Update Date	Revision Type	Reference	Section Description	Description of Revision	New or Deletion
1/16/2026	L&D Vol. 1	101.3	Classification Used in ODOT Design Criteria	Updated Office of Systems Planning and Program Management to Office of Technical Services	
1/16/2026	L&D Vol. 1	105.5.1	Documentation Format	Updated Safety Analysis Guidelines link & updated Office of Program Management to Office of T.E.D.	
1/16/2026	L&D Vol. 1	106.1	General	Updated Office of Program Management to Office of T.E.D.	
1/16/2026	L&D Vol. 1	106.3	Data-Driven Safety Analysis	Updated Safety Analysis Guidelines link & updated Office of Program Management to Office of T.E.D.	
1/16/2026	L&D Vol. 1	106.4	Data-Driven Safety Analysis Documentation	Modified language on when safety should be considered for projects. Updated Safety Analysis Guidelines link & updated Office of Program Management to Office of T.E.D.	
1/16/2026	L&D Vol. 1	Figure 107-1	Non-Complex Project Flowchart	Deleted because this figure is managed by Safety and posted to their website	Deletion

## 101.3 Classification Used in ODOT Design Criteria

Figure 107-1 Non-Complex Projects (No Alternative Analysis)

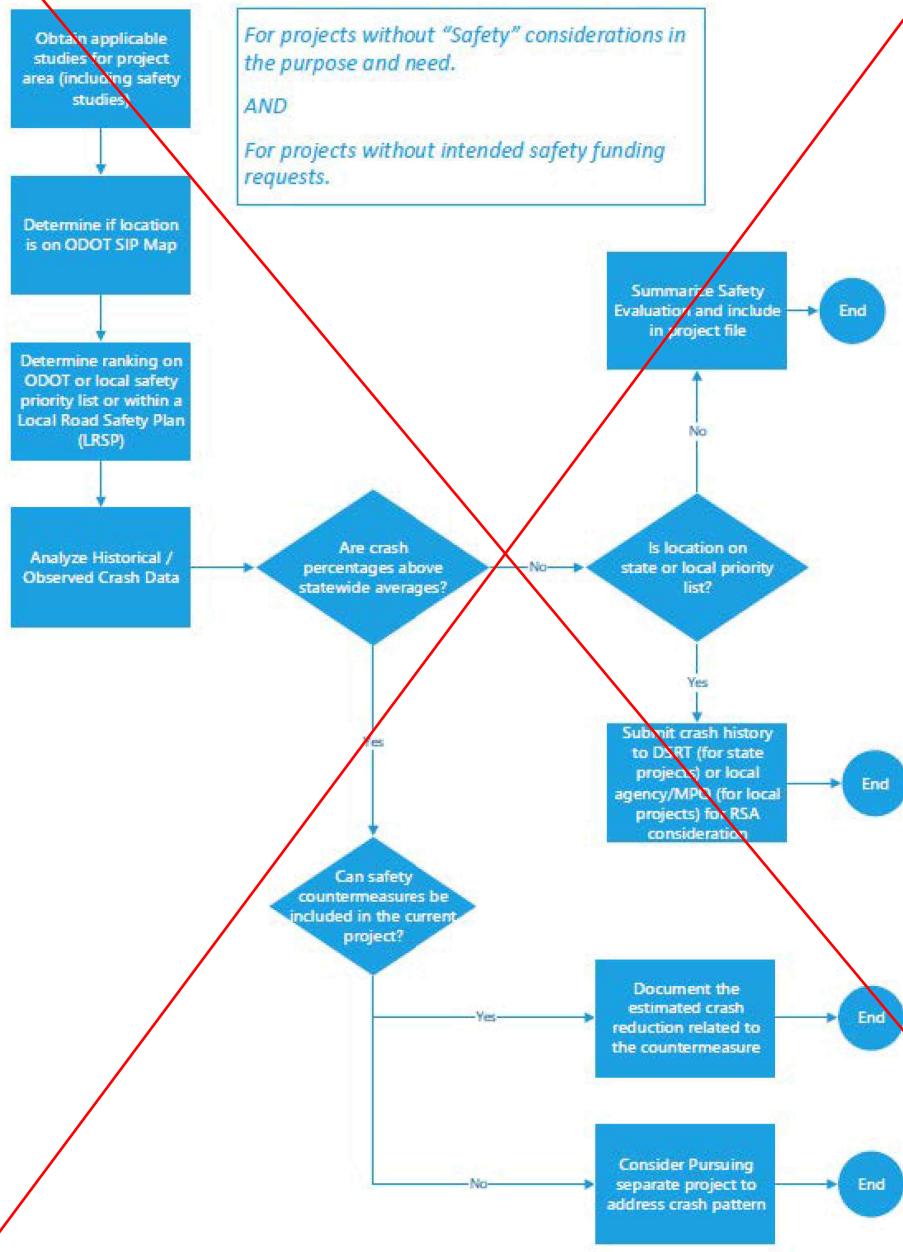
1/16/2026	L&D Vol. 1	Figure 107-2	Complex Projects Assessment with Alternatives Analysis without Safety	Deleted because this figure is managed by Safety and posted to their website	Deletion
1/16/2026	L&D Vol. 1	Figure 107-3	Complex Projects Assessment with Alternative Analysis with Safety	Deleted because this figure is managed by Safety and posted to their website	Deletion
1/16/2026	L&D Vol. 1	Figure 202-2	Maximum Degree of Curve	Corrected errors	
1/16/2026	L&D Vol. 1	Figure 202-5	Methods of Superelevation Rotation	Corrected print-error (letter A was missing in multiple locations)	
1/16/2026	L&D Vol. 1	305.2	Types and Uses	Added Type 11 curb	
1/16/2026	L&D Vol. 1	307.6.4	Adjacent to Noise Sensitive Areas	Revised Noise Wall contact to Statewide Noise Wall Coordinator	
1/16/2026	L&D Vol. 1	401.3	Crossroad Alignment	Added guidance for curves approaching a stop-controlled intersection	
1/16/2026	L&D Vol. 1	Figure 401-11	Double Left Turn Lanes	Corrected Green Book sheet reference in note 2

# DELETE FIGURE

Figure 107-3 Complex Projects Assessment with Alternative Analysis and Safety Component

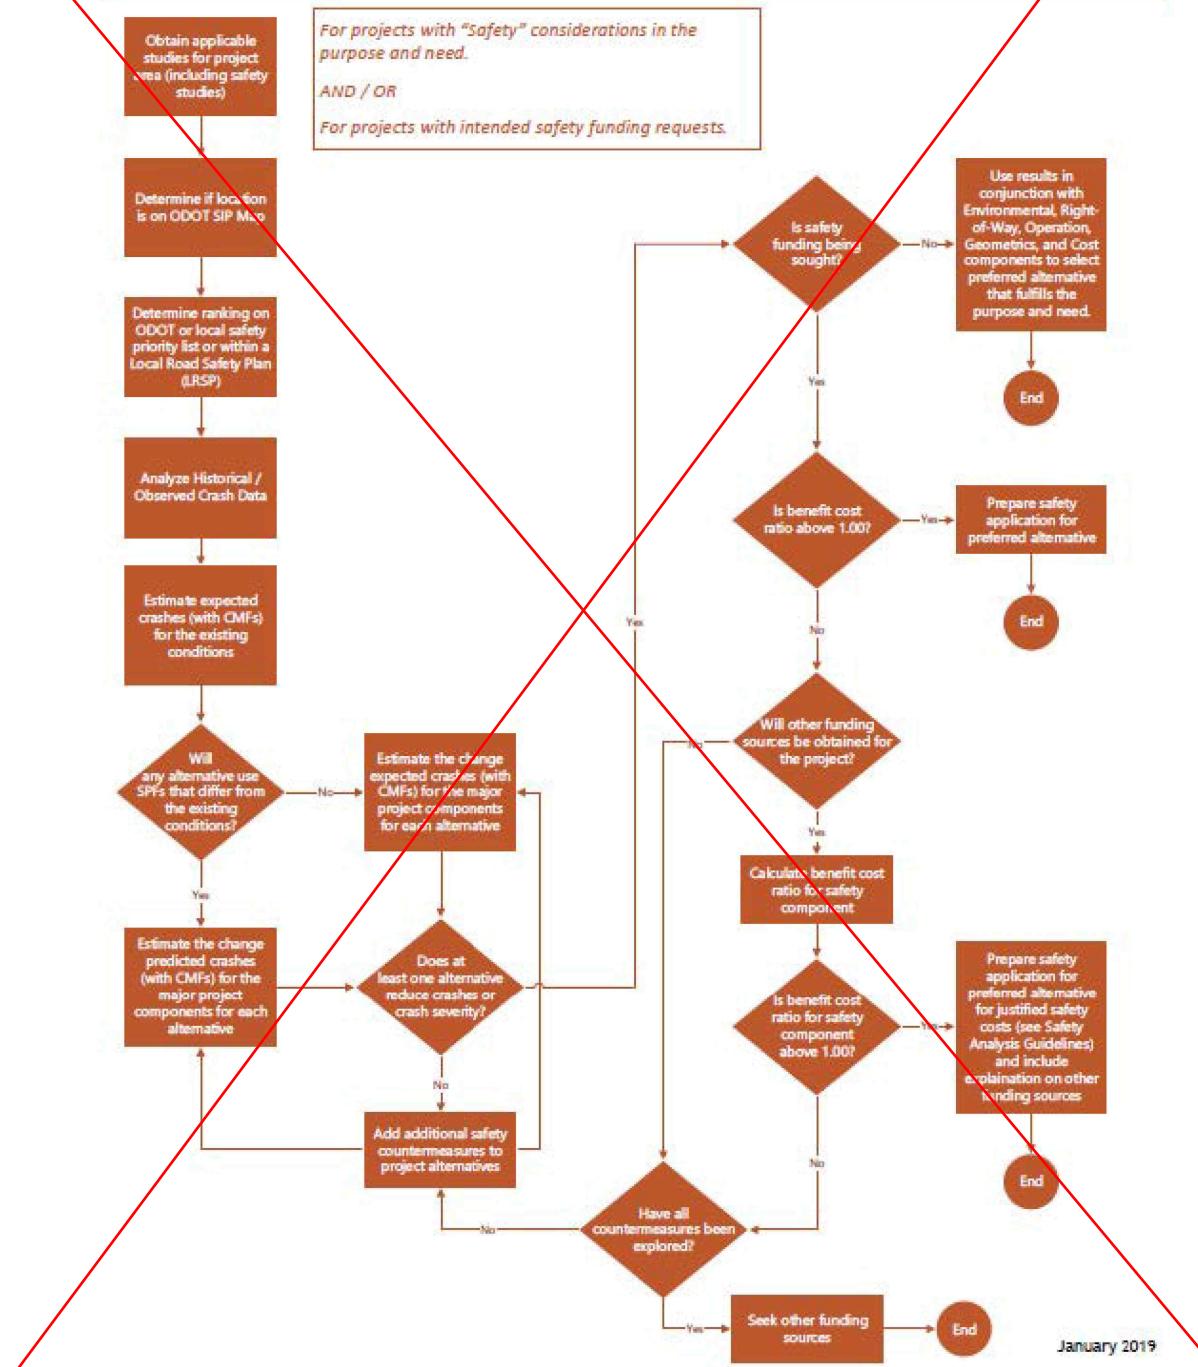
# DELETE FIGURE

603-2

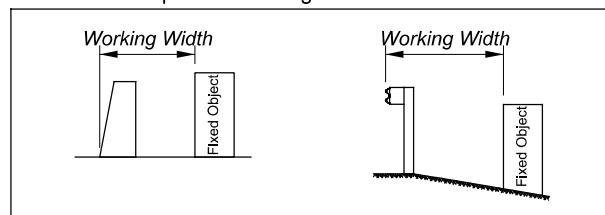
1/16/2026	L&D Vol. 1	Figure 603-2	TYPICAL PERMANENT BARRIER USES & WORKING WIDTHS	Added working width information for various details that were added to MGS-2.1, added MGS-2.2, and revised 81" to Type N	
1/16/2026	L&D Vol. 1	Example 602-2	Length of Need at a Large Culvert	Completely new version of this sample problem using modern standards	
1/16/2026	L&D Vol. 1	Example 602-4	Barrier on the Outside of a Curve	Revised calculations and improved graphic readability	
1/16/2026	L&D Vol. 1	1002.2	HSM for Evaluation	Updated Safety Analysis Guidelines link & updated Office of Program Management to Office of T.E.D.	
1/16/2026	L&D Vol. 1	Plan Note R112a	ITEM 606 – ANCHOR ASSEMBLY, MGS TYPE B	Updated designer notes for system length, LON, and offset guidance due to new device (4F-T)	
1/16/2026	L&D Vol. 1	Plan Note R113a	ITEM 606 – ANCHOR ASSEMBLY, MGS TYPE E	Fixed typo	
1/16/2026	L&D Vol. 1	Plan Note R116	MGS GUARDRAIL INSTALLED IN ASPHALT	Revised asphalt item, allowable depth to 2", and other minor edits in conjunction with new detail added to MGS-2.1

MGS Top Mounted Culvert Detail #1	MGS-2.1 (Sheet P.6)	4'-3"	Roadside protection along box culverts with shallow cover
	MGS Top Mounted Culvert Detail #2	MGS-2.1 (Sheet P.6)		
	MGS Barrier Design (Double-Sided MGS)	MGS-2.1 MGS-6.1 MGS-6.2	5'	Narrow medians where deflections can be tolerated.
	MGS Barrier Design with Rub Rail	MGS-2.2	4'-6"	Narrow medians with steeper than 10:1 slopes on the median/rub rail side
	MGS Long-Span	MGS-2.3	8"	*When the headwall is flush to grade, the back of the post can be aligned with the near side of the headwall. But if the headwall protrudes above grade, the system should be offset 8' from the fixed object. Used primarily to span culverts that have limited depths of cover.
	Socketed Weak Post Mounting	MGS-2.4	5'	Used primarily on precast structures that have limited depths of cover
Permanent Concrete Barrier (see Note 2)	Type B	RM-4.3	Width of Barrier (28")	Narrow medians
